MEMORANDUM

To: Development Review Board
From: Mary O'Neil, AICP, Senior Planner *monell*
Date: August 5, 2014
RE: ZP 14-1311SP, 86 Main Street

Request: Sketch Plan review
for proposed twenty three unit
apartment building with office
space, 8 internal parking spaces.

SITE
PLAN

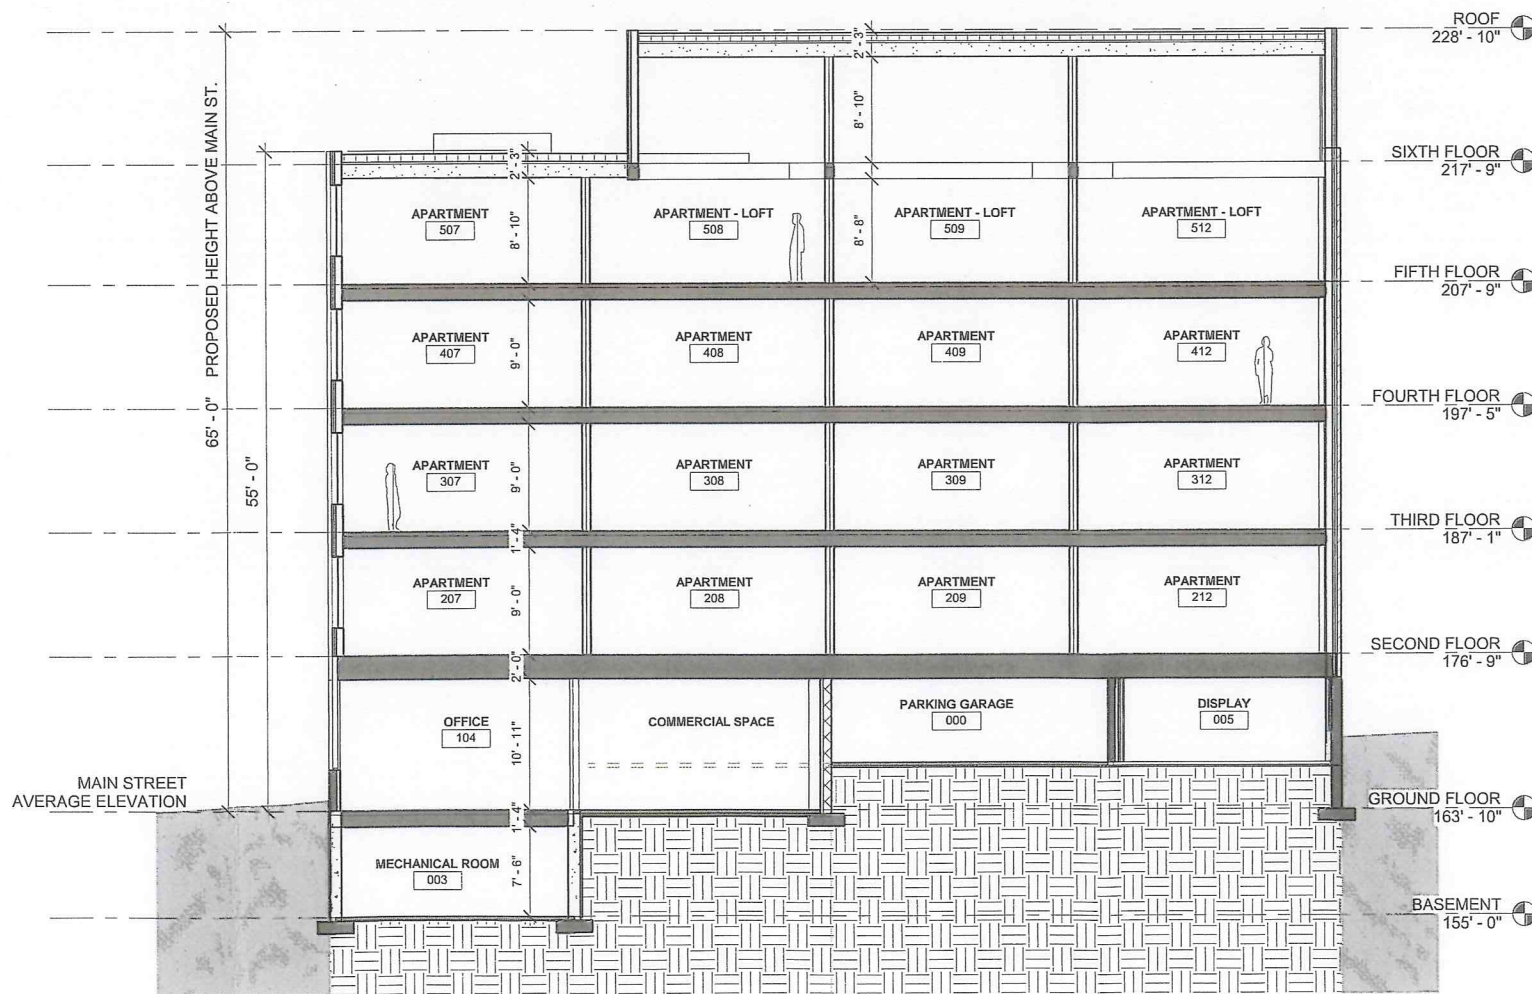
Max lot coverage permissible is 100%, with allowable setbacks of 0. (Although front setback is 12' from curb. There are 2 street frontages within this proposal.) Setbacks from the sidewalk are not annotated on the site plan, and must be to assure the required 12' from curblane.

The north side of the proposed building addition has two openings that exit onto an existing 10' right-of-way. It is not clear who owns the land, but the ROW provides the setback required by this section.

This building is proposed to be attached to the existing 2 story building, so the only boundary line it approaches is on the north (Pine Street) side. The site plan identifies an existing 10' ROW. It is not clear who owns that ROW, but as presented, the building meets the required setback for abutting property.

sheet title:
OPTION A
EAST SECTION &
STREET FACADES

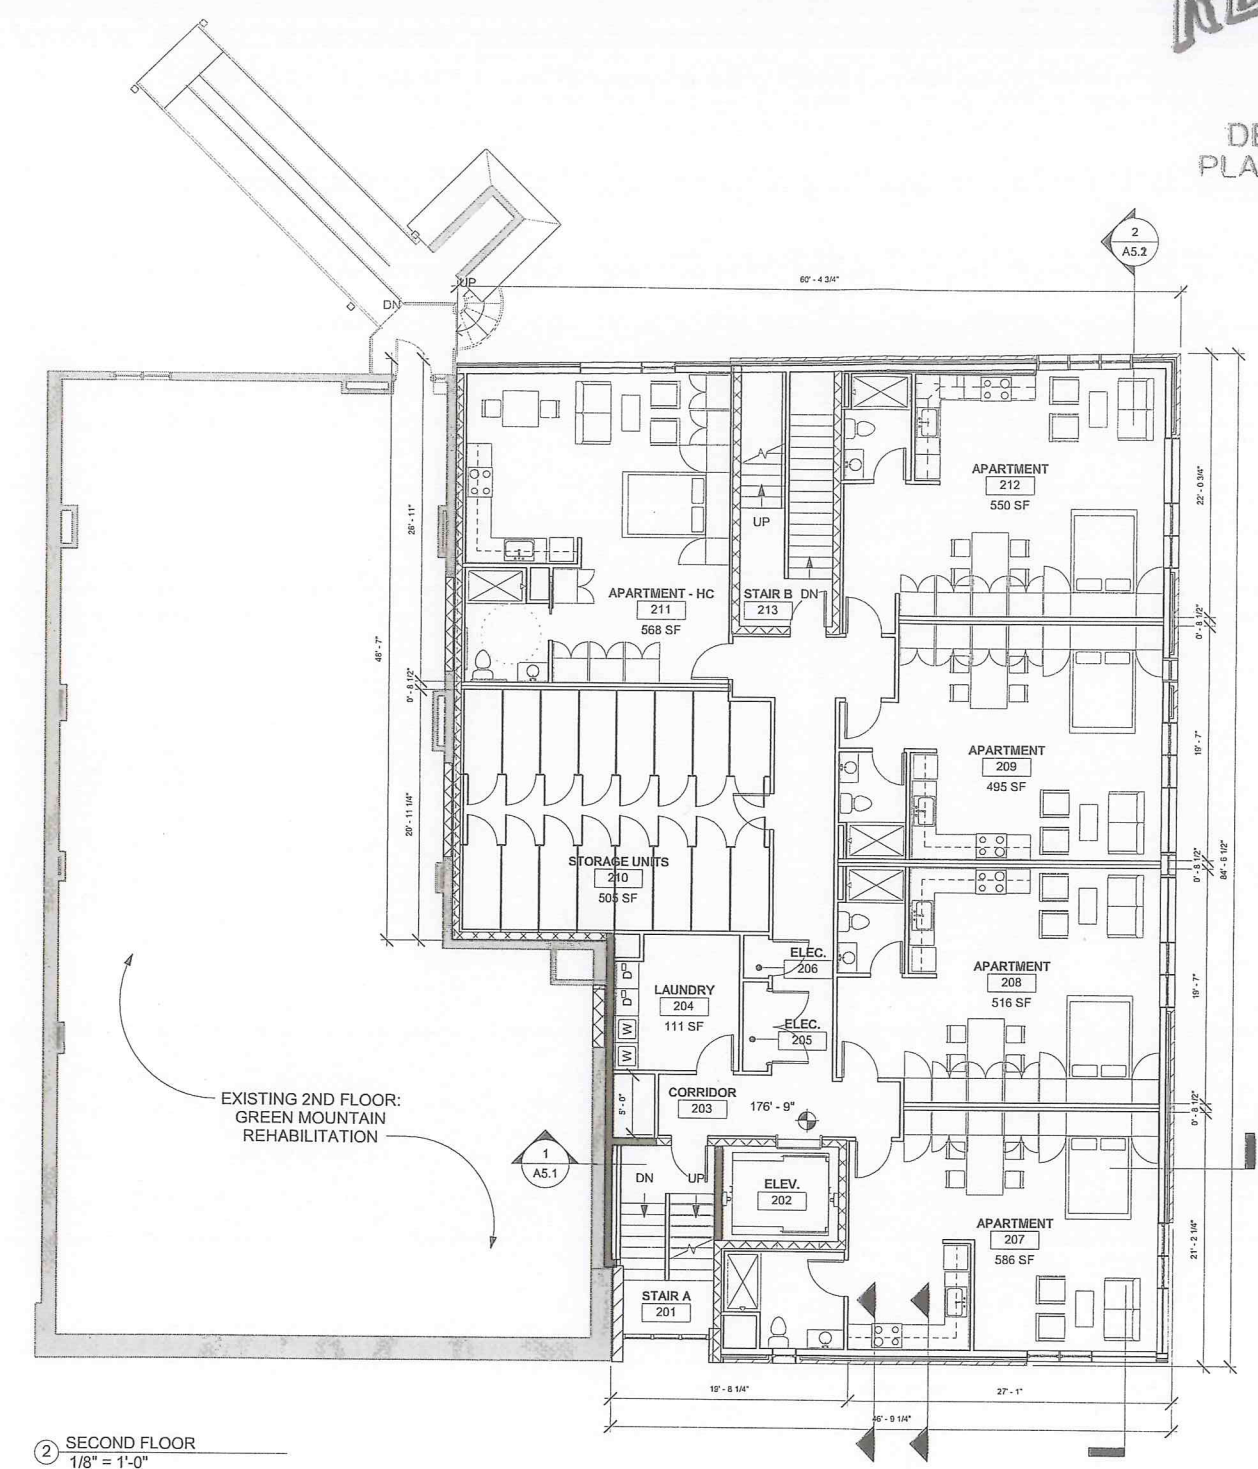
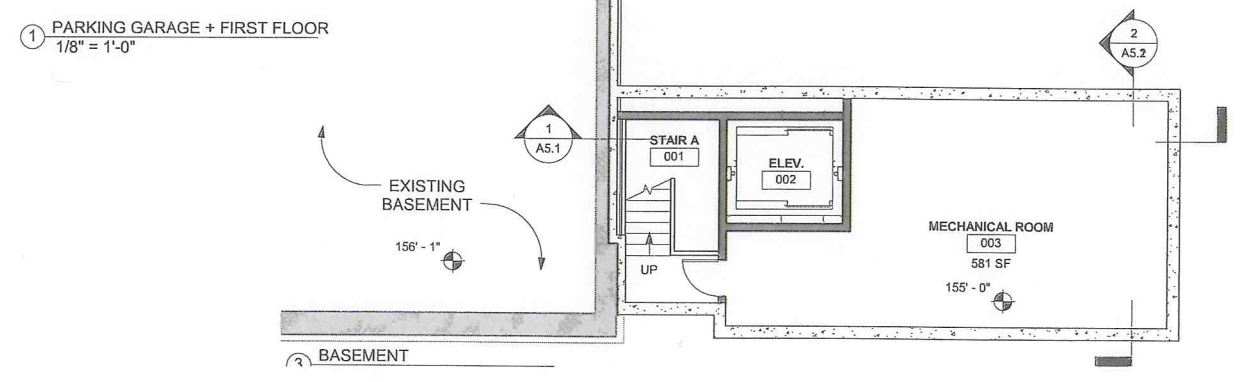
Elevations illustrate an intended setback from Main Street at 55' height. Main Street's ROW width is 99'. The setback from the front property line for the building above 55' should be at least 25% of that ROW width, not to exceed 40'. Although a required setback is noted on sixth floor plans, the measurement is not annotated. This measurement (minimally 24.75') should be annotated on the plans.
